Car Stereo Service Bulletin

Model: RM-X2/XK-8D

No. 134

Subject: XK-8D Cannot Be Operated With
RM-X2

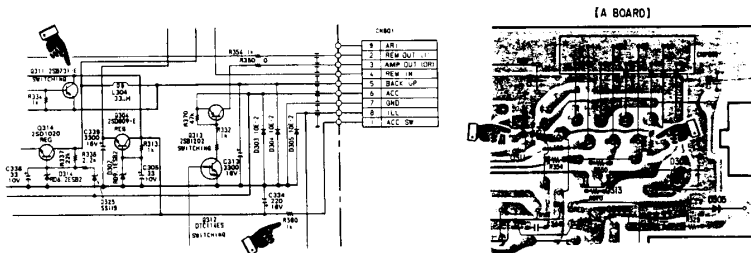
Symptom:
(11)

When an RM-X2 is connected with an XK-8D, it does not operate. The current which is supplied by the RM-X2 is insufficient for driving the XK-8D.

Solution: Please replace R380, Q311 as follows:

Ref. No.	Description		Part Number
	Former	New	
R380	1k Ohm	1 Ohm	1-249-447-11
Q311	2SB731	2SB1202	8-729-805-20
